AGENDA
JACKSON MUNICIPAL REGIONAL PLANNING COMMISSION
CITY HALL – GEORGE A. SMITH MEETING ROOM
FIRST FLOOR – 109 EAST MAIN STREET – SUITE 107
MAY 5, 2021 – 3:00 P.M.

MINUTES
JACKSON MUNICIPAL REGIONAL PLANNING COMMISSION
CITY HALL – GEORGE A. SMITH MEETING ROOM
FIRST FLOOR – 109 EAST MAIN STREET – SUITE 107
APRIL 7, 2021—3:00 P.M.

SITE PLAN STAFF REPORT Chic-Fil-A

SHEET 1
 SKETCH PLAN H

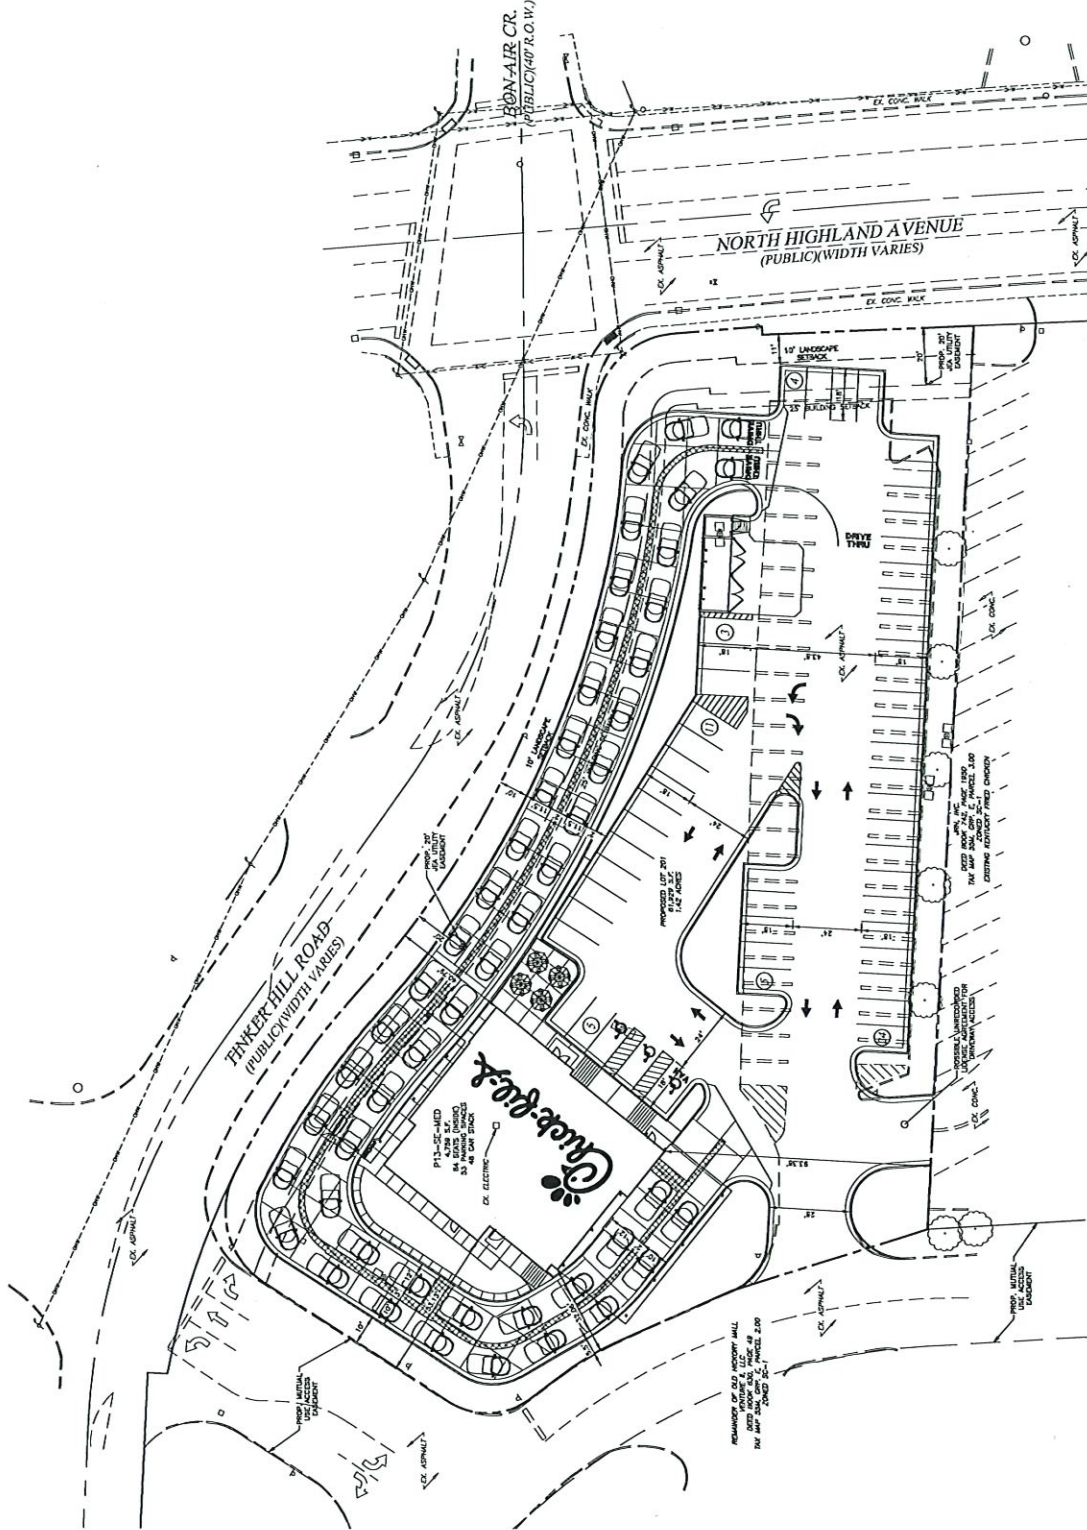
The Engineering department will need a Stormwater Detention Analysis report for a 2,5, and 10 year storm showing no-net increase in stormwater runoff for the site. The capacity of the area detention pond should be shown to control the volume of stormwater runoff from a 2-year, 5-year and a 10-year frequency 24-hour duration storm. Please include summary of findings in front section of the report and if pond capacity does or does not exceed a 100-year storm. Also, the Engineering had the following comments on the provided traffic study.

- Re-timing the traffic signal at the intersection of N. Highland Avenue and Tinker Hill Road, to be based on actual observed traffic volumes after Chick-fil-a is fully operational rather than predicted traffic volumes.

- Re-timing of the intersections of N. Highland Avenue and N. Parkway and of N. Highland Avenue and Old Hickory Boulevard is not required as the needed timing changes can be accommodated within in the existing cycle lengths dictated by coordination patterns within the signal group.

- Re-striping the eastbound approach to the N. Highland Avenue and Tinker Hill Boulevard intersection to provide continuous left-turn storage from subject intersection to the beginning of the westbound left-turn lane into the Mall driveway thus eliminating the separately defined left-turn lane into the Highland Place shopping center.

- No geometric changes to the subject intersection are recommended.
- No changes to the traffic signal phasing arrangement are recommended.

SITE PLAN LOCATION MAP
PROPOSED STAYAPT SUITES (LOCATED IN SC-1 - PLANNED COMMERCIAL DISTRICT)
#86 PARKSTONE PLACE

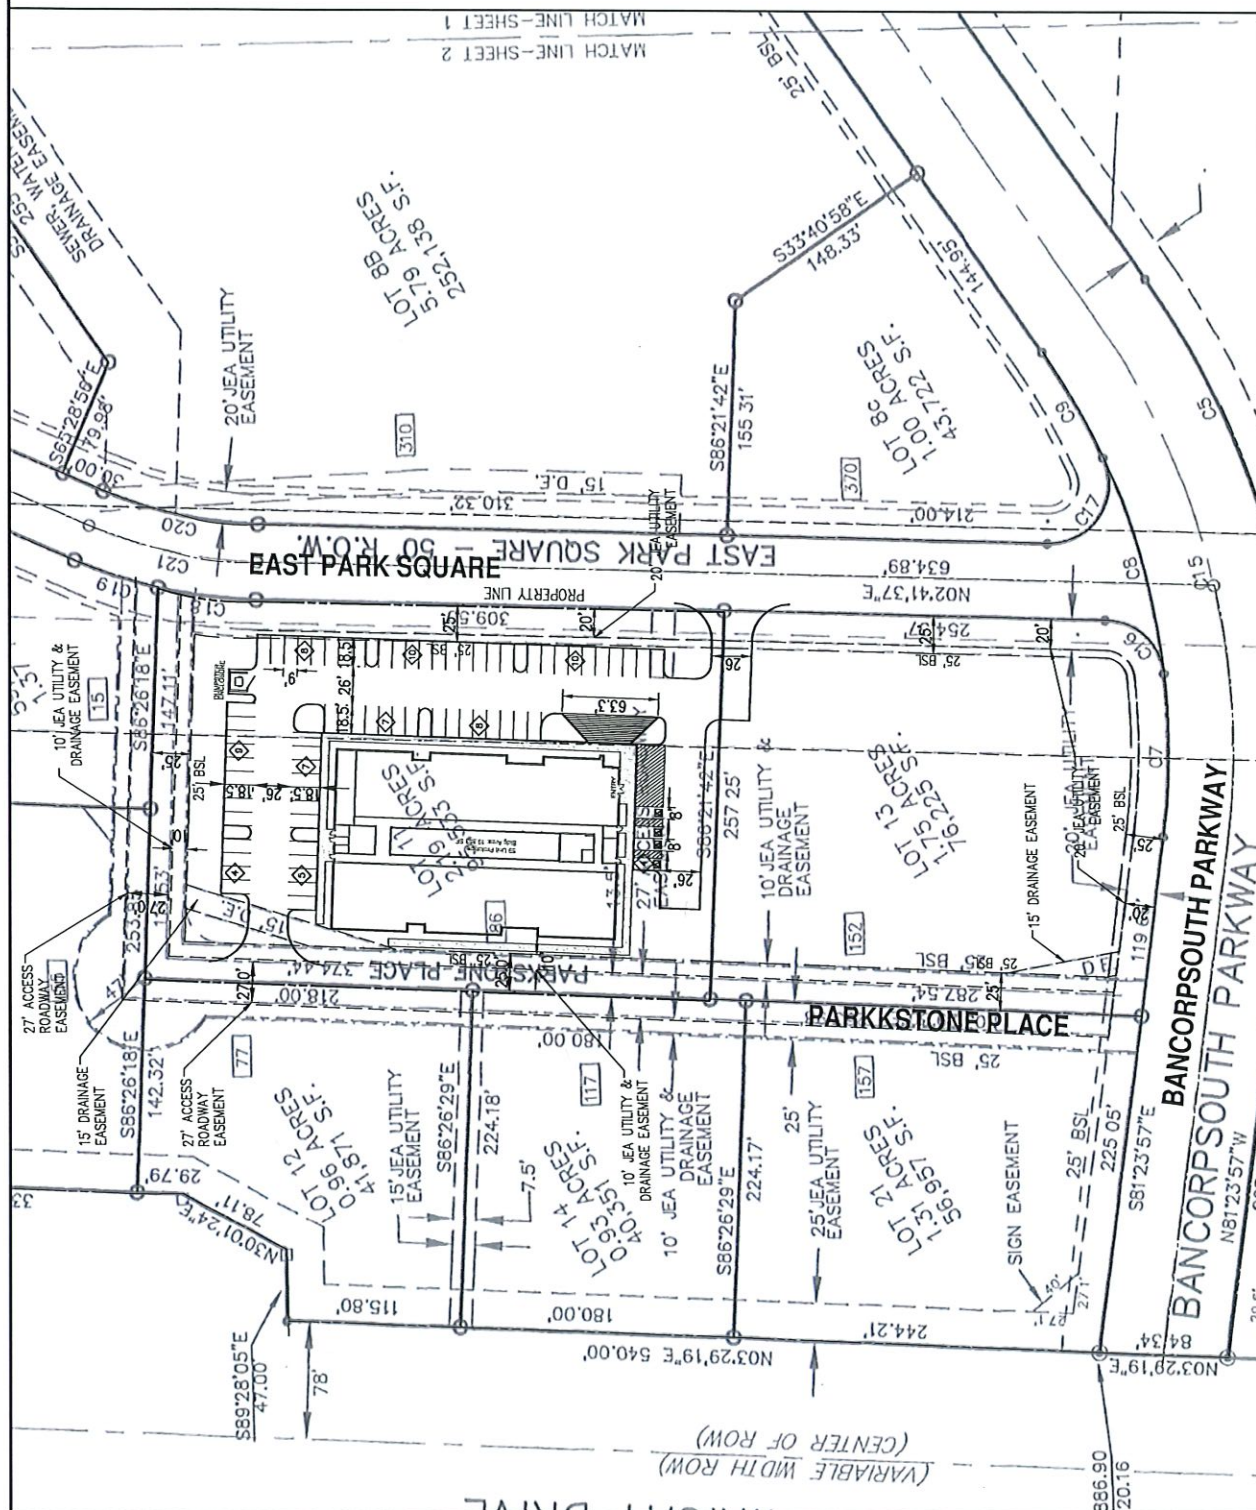
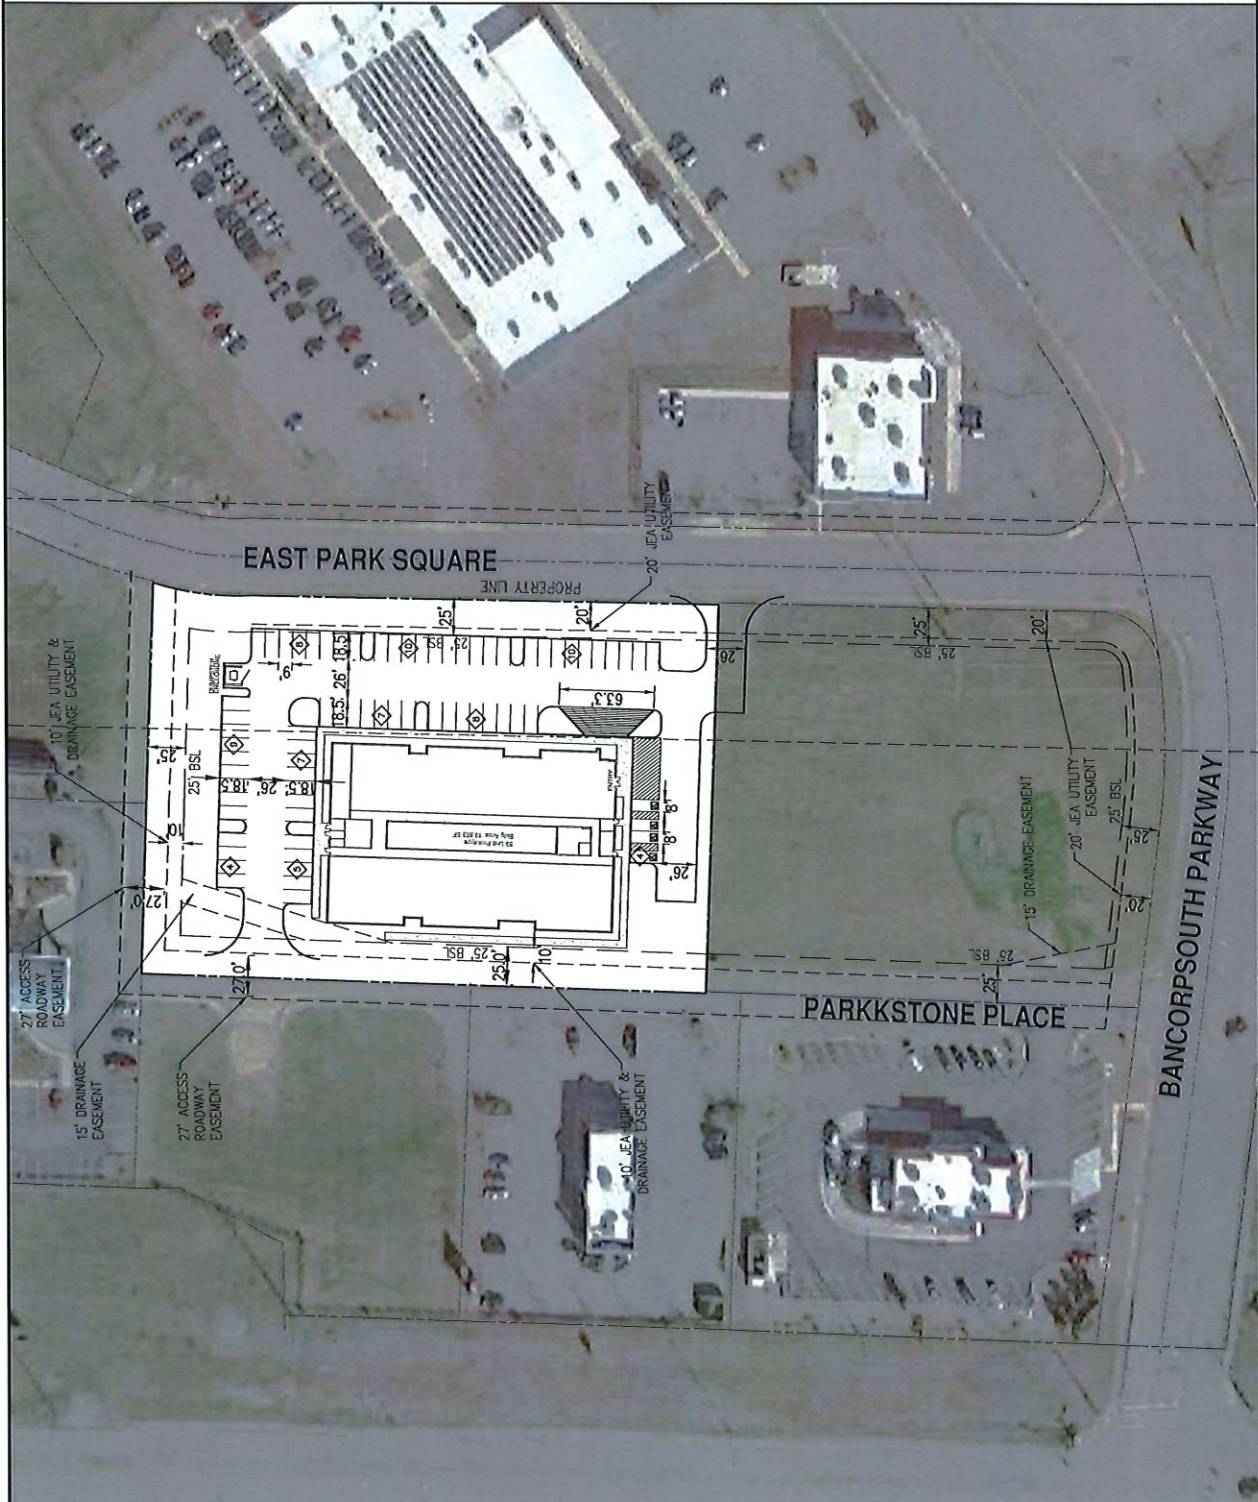
The site plan shows that there will be 94 parking spaces. All parking spaces and aisle widths will comply with the Zoning Ordinance parking requirements. If there are to be any bar or conference areas, additional parking may be required.

The Engineering department will need a Stormwater Detention Analysis report for a 2, 5, and 10 year storm showing no-net increase in stormwater runoff for the site. The capacity of the area detention pond should be shown to control the volume of stormwater runoff from a 2-year, 5-year and a 10-year frequency 24-hour duration storm. Please include summary of findings in front section of the report and if pond capacity does or does not exceed a 100-year storm.

SHEET NUMBER
C-111
DESCRIPTION
SITE PLAN

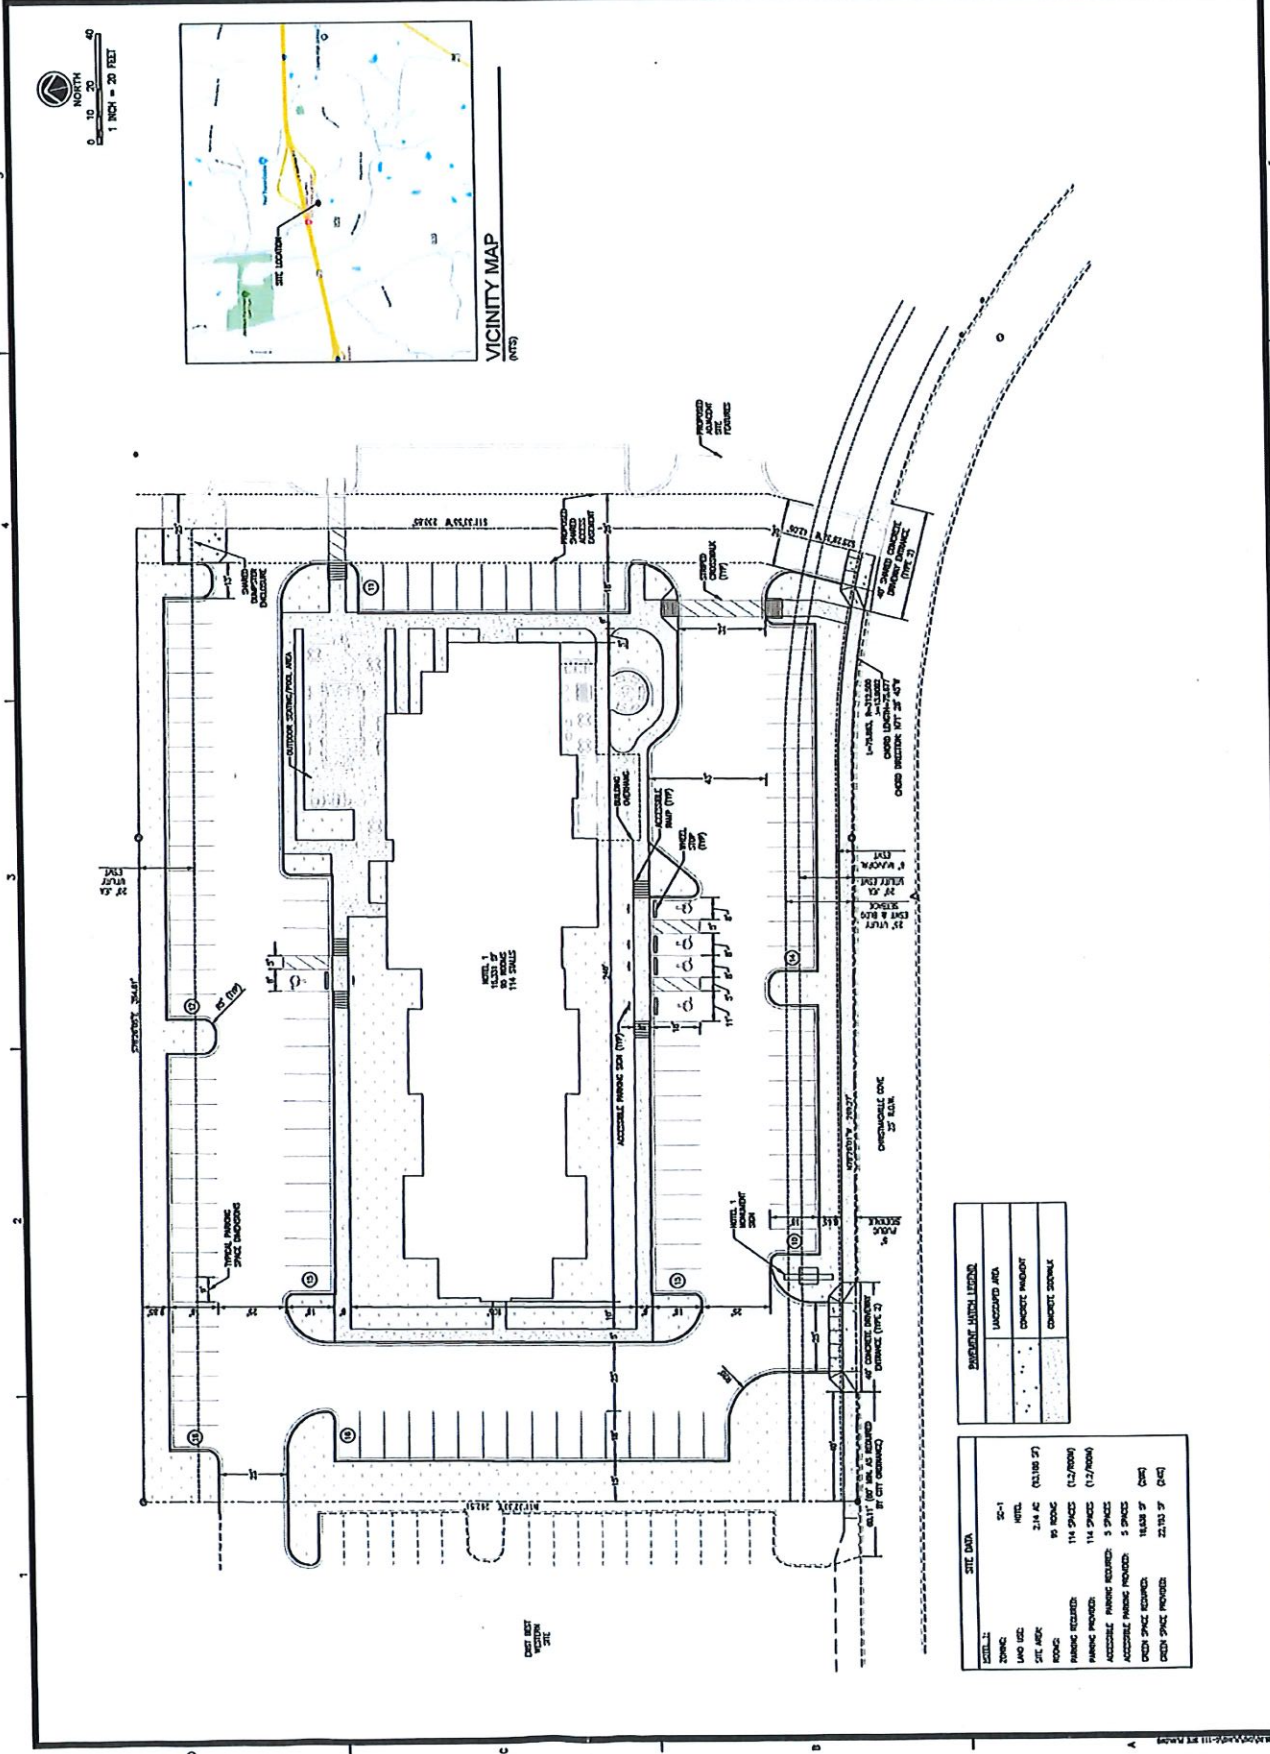
The site plan shows that there will be 114 parking spaces. All parking spaces and aisle widths will comply with the Zoning Ordinance parking requirements. If there are to be any bar or conference areas, additional parking will be required.

The Engineering department will need a Stormwater Detention Analysis report for a 2, 5, and 10 year storm showing no-net increase in stormwater runoff for the site. The capacity of the area detention pond should be shown to control the volume of stormwater runoff from a 2-year, 5-year and a 10-year frequency 24-hour duration storm. Please include summary of findings in front section of the report and if pond capacity does or does not exceed a 100-year storm.

SITE LOCATION MAP
SITE PLAN - HOTEL #2
#2511 CHRISTMASVILLE COVE

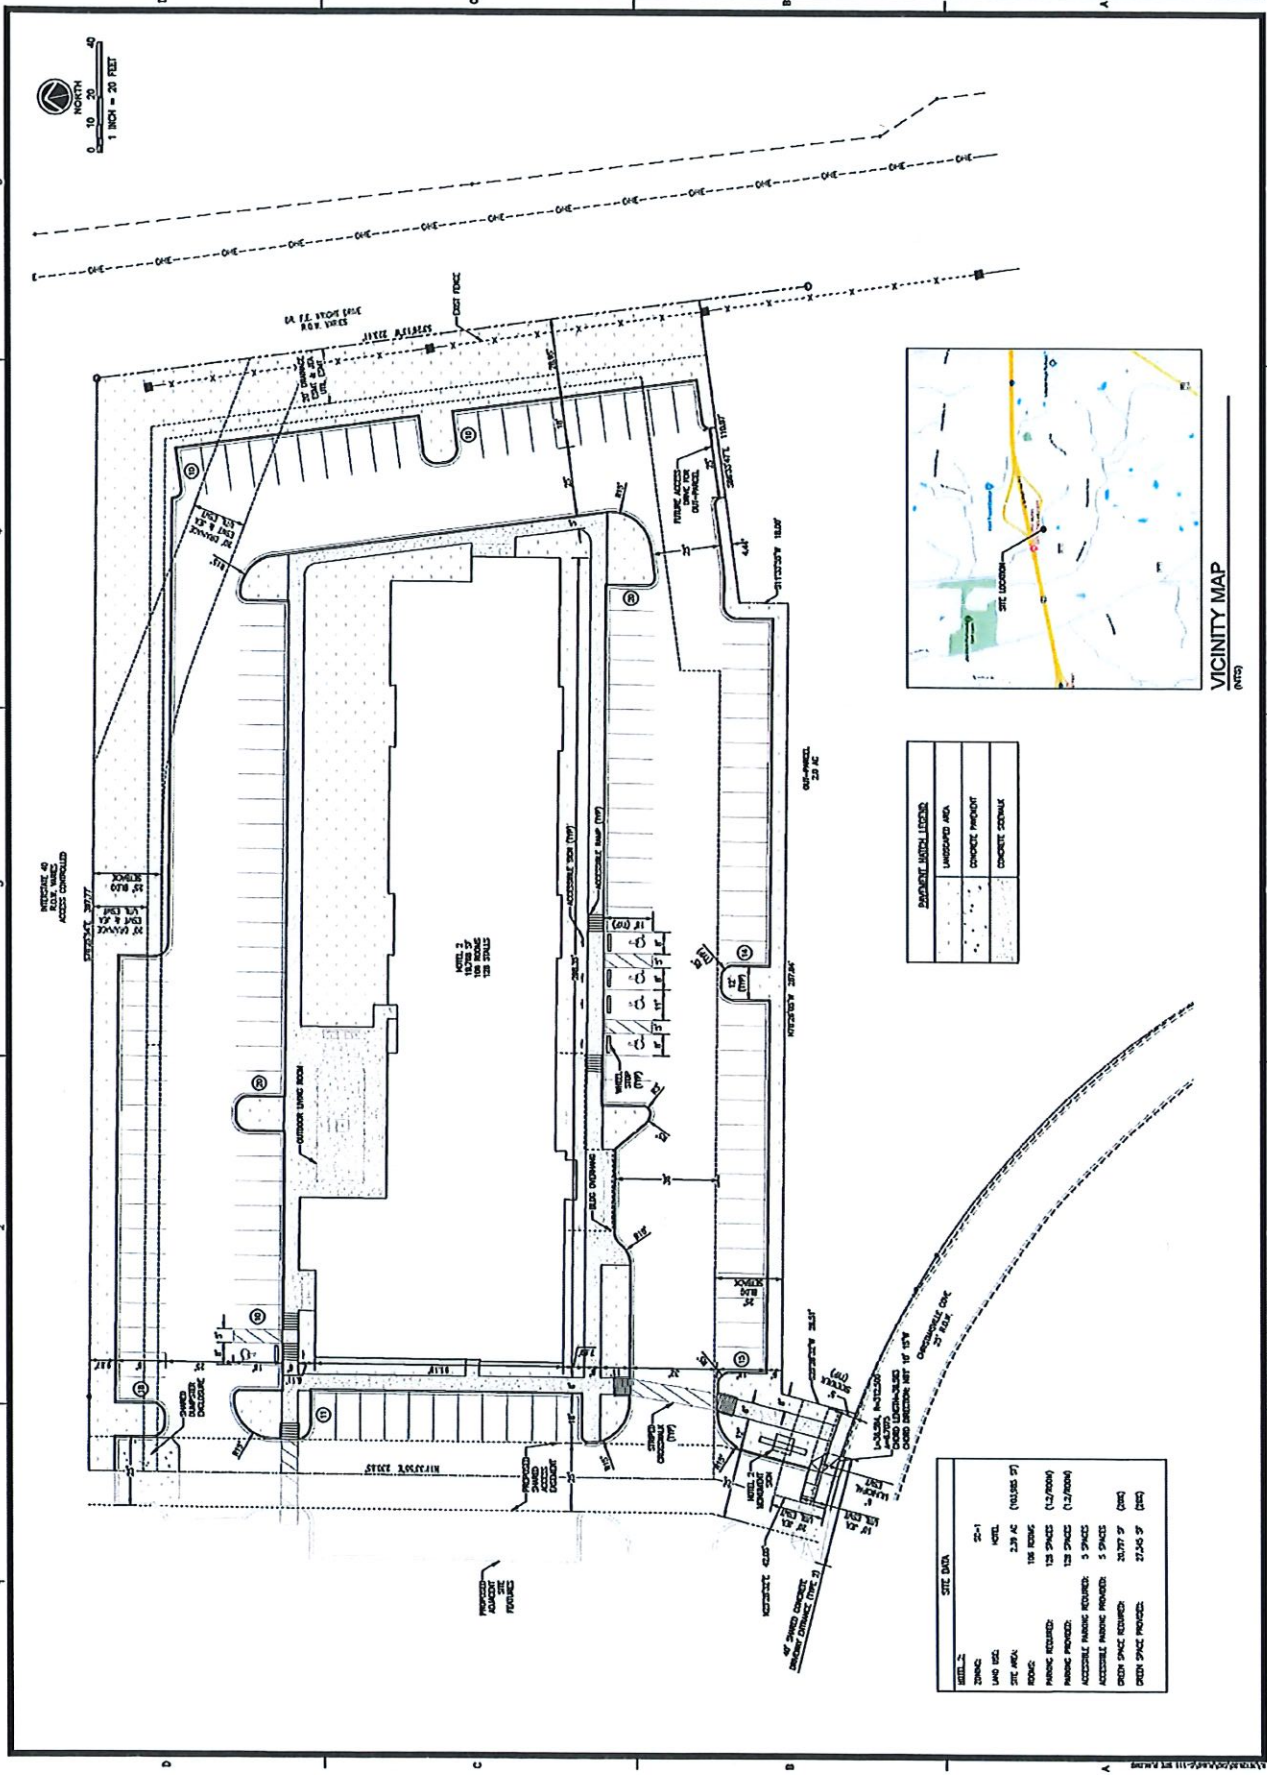
The site plan shows that there will be 128 parking spaces. All parking spaces and aisle widths will comply with the Zoning Ordinance parking requirements. If there are to be any bar or conference areas, additional parking will be required.

The Engineering department will need a Stormwater Detention Analysis report for a 2, 5, and 10 year storm showing no-net increase in stormwater runoff for the site. The capacity of the area detention pond should be shown to control the volume of stormwater runoff from a 2-year, 5-year and a 10-year frequency 24-hour duration storm. Please include summary of findings in front section of the report and if pond capacity does or does not exceed a 100-year storm.
